Appliance Standards Awareness Project
American Council for an Energy-Efficient Economy
Consumer Federation of America
National Consumer Law Center, on behalf of its low-income clients
Natural Resources Defense Council
Northwest Energy Efficiency Alliance

RE: Docket Number EERE-2019-BT-TP-0037/RIN 1904-AE83: Notice of Proposed Rulemaking for Test Procedure for Consumer Boilers

Figure 1. Boiler efficiency vs. return water temperature for condensing boilers⁶

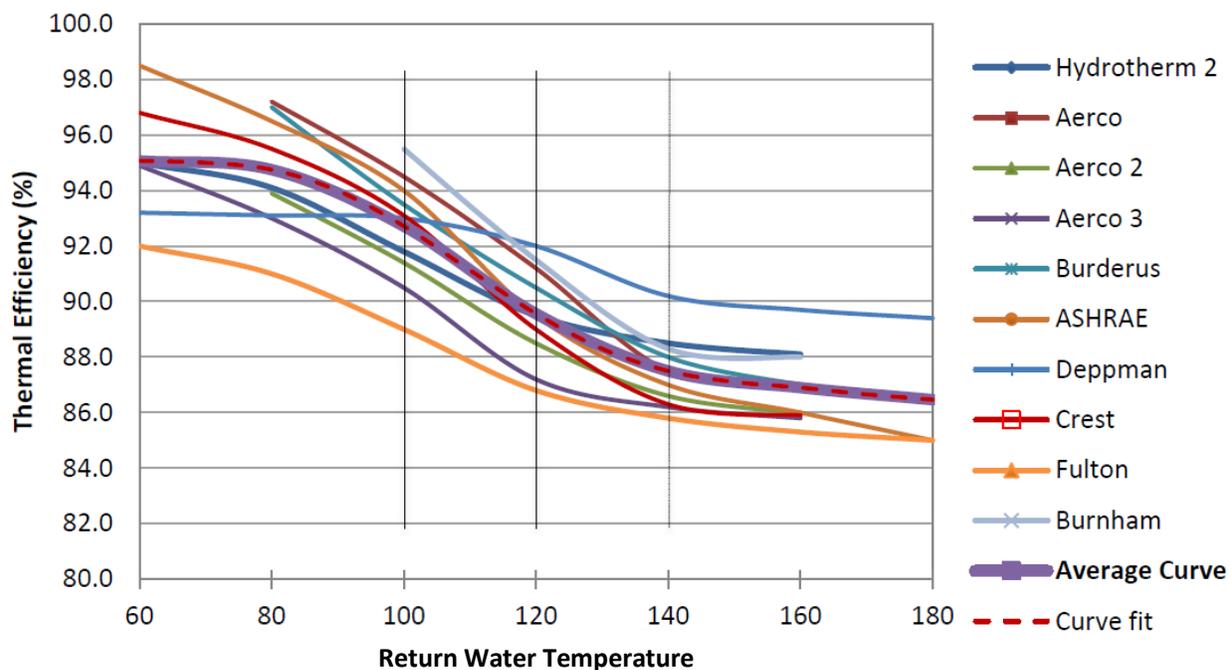
We urge DOE to further investigate appropriate return water temperatures (RWTs) that may more accurately capture relative boiler efficiencies. In the current test procedure, the required nominal RWT is 120°F ± 2°F for condensing boilers and 120°F to 124°F for non-condensing boilers. In response to the May 2020 request for information (RFI), DOE received comments that recommended that the Department require condensing boilers to be tested at two separate RWTs. DOE responded in the NOPR and tentatively determined that the single RWT specified in the current test procedure is reasonably representative given the wide range of potential operating conditions.⁴ However, as seen in Figure 1 below from the April 2022 preliminary technical support document (PTSD), the relative efficiencies of condensing boiler models can vary significantly at different RWTs. Thus, we believe that the single temperature specification of 120°F may not be a good predictor of efficiency at other RWTs and testing at multiple RWTs may help in differentiating among different condensing boiler models. Therefore, we encourage DOE to consider requiring condensing boilers to be tested at multiple RWTs, which would provide consumers with a more accurate relative ranking of boiler efficiencies. Additionally, we encourage DOE to consider testing non-condensing boilers at a higher temperature. For example, DOE could consider requiring testing non-condensing boilers at 158°F and condensing boilers at 108°F and 158°F to reflect “low” and “high” RWT applications as outlined in the April 2022 PTSD.⁵
